Item Name: AS350/AS355 Quick Release Heli-Utility-Basket™ Long, Heavy Duty Lid

TO AMEND INSTALLATION INSTRUCTIONS D350-607-3 Rev.D,
INSTALLATION INSTRUCTIONS D350-607-4 Rev. C AND
INSTRUCTIONS FOR CONTINUED AIRWORTHINESS ICA-D350-607 R

DESIGN	AJS	DART AEROSPACE LTD HAWKESBURY, ONTARIO, CANADA	
DRAWN	AJS		
CHECKED	<i>[Signature]</i>	DRAWING NO.	REV. A
MFG. APPR.	N/A	DSI 9699	SHEET 2 OF 2
APPROVED	<i>[Signature]</i>	TITLE	SCALE
DE APPR.	<i>[Signature]</i>	LUG REPLACEMENT	NTS
DATE	14.05.16	COPYRIGHT © 2014 BY DART AEROSPACE LTD THIS DOCUMENT IS PRIVATE AND CONFIDENTIAL AND IS SUPPLIED ON THE EXPRESS CONDITION THAT IT IS NOT TO BE USED FOR ANY PURPOSE OR COPIED OR COMMUNICATED TO ANY OTHER PERSON WITHOUT WRITTEN PERMISSION FROM DART AEROSPACE LTD.

FIGURE 1: INSTALLATION OF D4775-041 FWD STRUT

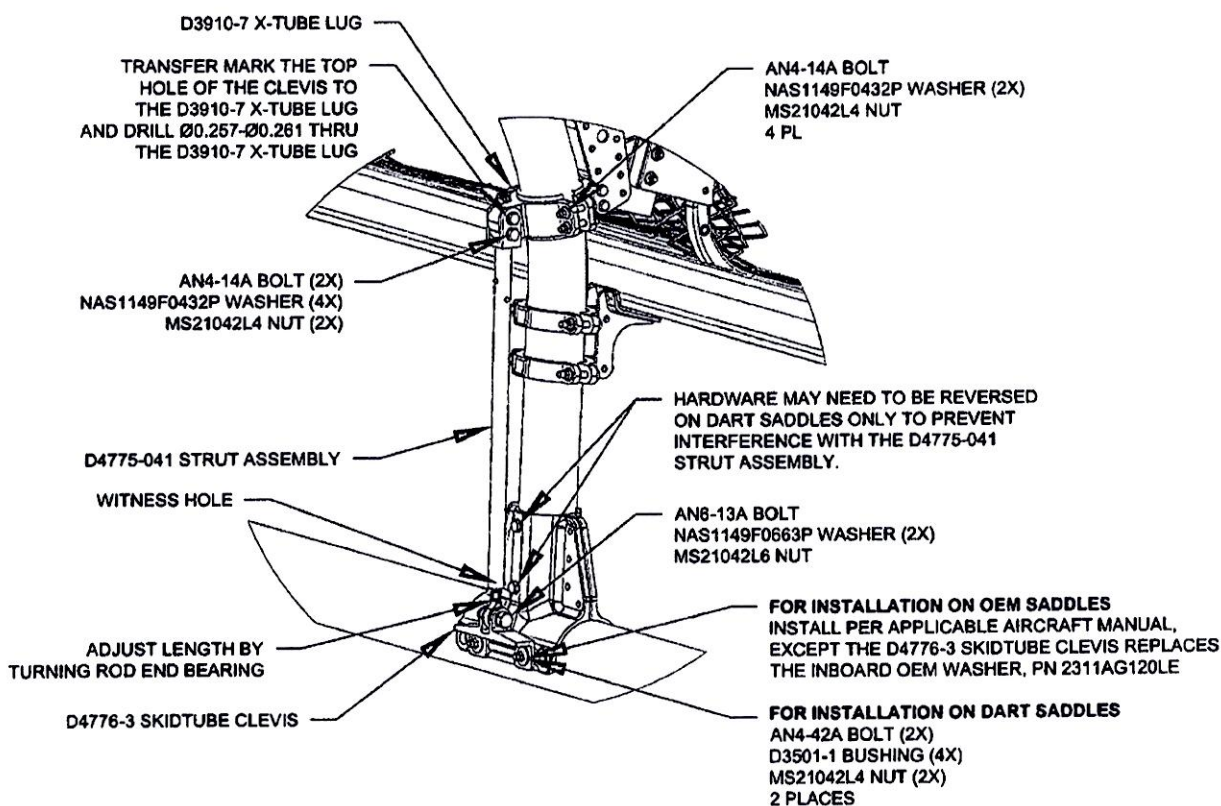
Modify the quantities for D3910-5 and add D3910-7 as follows:

- 3.1 Substitute the Forward Lower D3910-5 X-Tube Lug with the D3910-7 X-Tube Lug as shown in Figure 1.
- 3.2 Install the forward D4775-041 Strut Assembly. Transfer mark from the upper hole on the clevis of the D4775-041 Strut Assembly to the D3910-7 X-tube Lug and drill thru the lug $\varnothing 0.257$ - $\varnothing 0.261$ as shown in Figure 1. Touch up chemical conversion coating per MIL-DTL-5541. Check the witness holes located at the bottom end of the D4775-041 Strut Assemblies to ensure that the thread from the rod end extends past the witness hole.
Torque MS21042L4/-4 nuts to 50-70 in-lbs (5.7-7.9 N-m). Torque MS21042L6/-6 nuts to 160-190 in-lbs (18.1-21.5 N-m).
- 3.3 Complete the installation in accordance with Installation Instructions D350-607-3 Rev. D or D350-607-4 Rev. C.
